**Enquiries:** Anna Borthwick  
**Telephone:** 03 5775 8525  
**Our Ref:** DA4940

**Development Plan for the land recognised as 'Anchorage Estate' CA 62,  
63 and Part 64 and 65, Mansfield**

**Statement of Conditions for the Development Plan for the land recognised as 'Anchorage Estate' CA 62, 63 and Part 64 and 65, Mansfield:**

**PS 610748P**

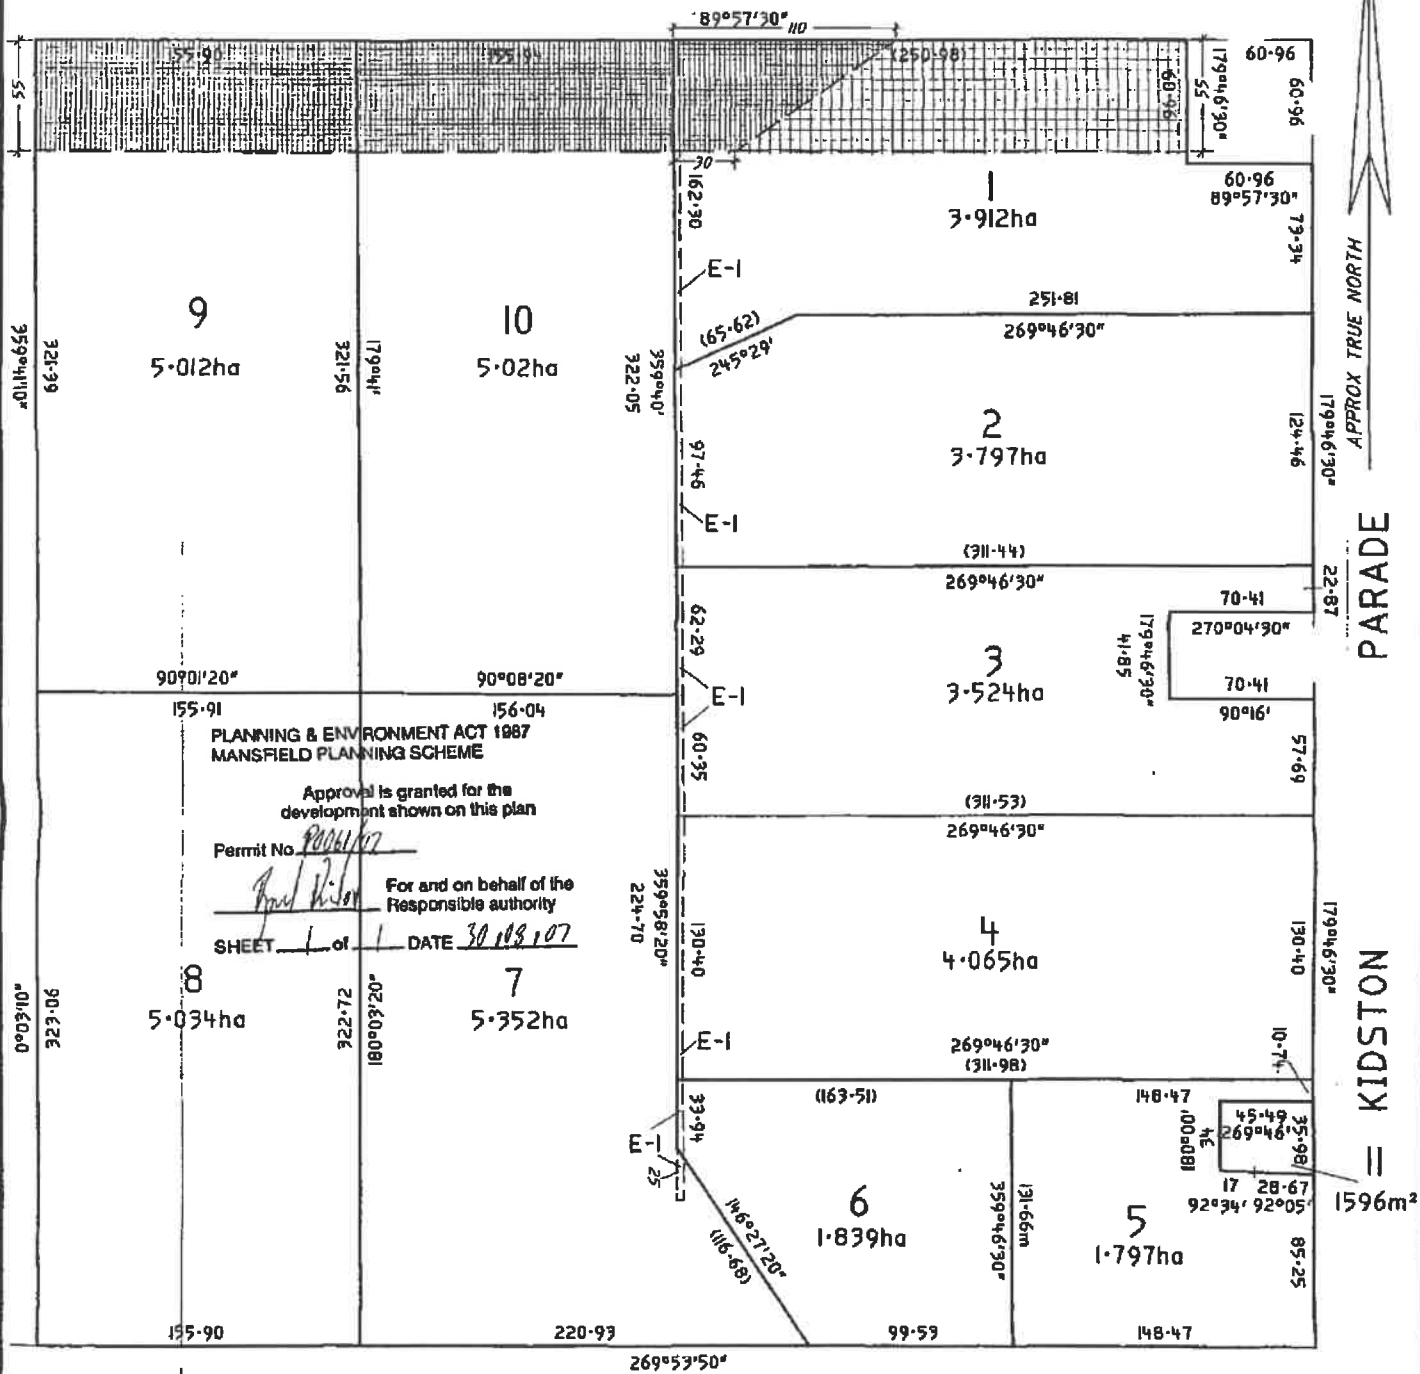
- 1. A amended Development Plan be submitted to demonstrate:**
  - a. The existing boundary of 235 Kidston Parade Mansfield is realigned to accommodate the existing wastewater disposal area currently servicing this lot.**
  - b. The effluent disposal envelopes on proposed Lots 7, 9 and 10 are located in accordance with EPA Code of Practice and to the satisfaction of the Responsible Authority.**
  - c. The buffer zone is extended to the electrical substation located at the eastern boundary of the subject site.**

6. The area identified as 'Effluent Wastewater Envelope' on the endorsed plan shall be set aside for this sole purpose and the site shall not be developed or altered other than in accordance with a 'permit to install' a septic system. Other inconsistent development shall not be undertaken at any time within that area.

- a. No direct access from Lot 1 to the Maroondah Highway shall be permitted. Access to Lot 1 shall be via Kidston Parade.**
- b. Only one access which is to be a joint access will be permitted from the Maroondah Highway to Lots 9 and 10.**

- d. Lots 9 and 10 shall be reshaped on the development plan so that their joint access can be located where Safe Intersection Sight Distance as described above, can be achieved.**

- e. A restriction is to be placed on the plan of subdivision showing the area within the proposed allotments that are within the buffer distances, as per Table 5 of the Environmental Protection Authority's (EPA) publication 'Recommended Buffer Distances for Industrial Residual Air Emissions', Number AQ2/86 dated July 1990 ('EPA Guideline'), and to the satisfaction of Goulburn Valley Region Water Authority.**

- a. Building envelopes to be located a minimum of 30 metres from the waterway.**
- b. Septic disposal envelope to be located a minimum of 60 metres from the waterway.**
- c. Any work on a declared waterway is subject to permit/approval under Bylaw No. 1.**
- d. All land within waterways should be set aside for waterway protection.**
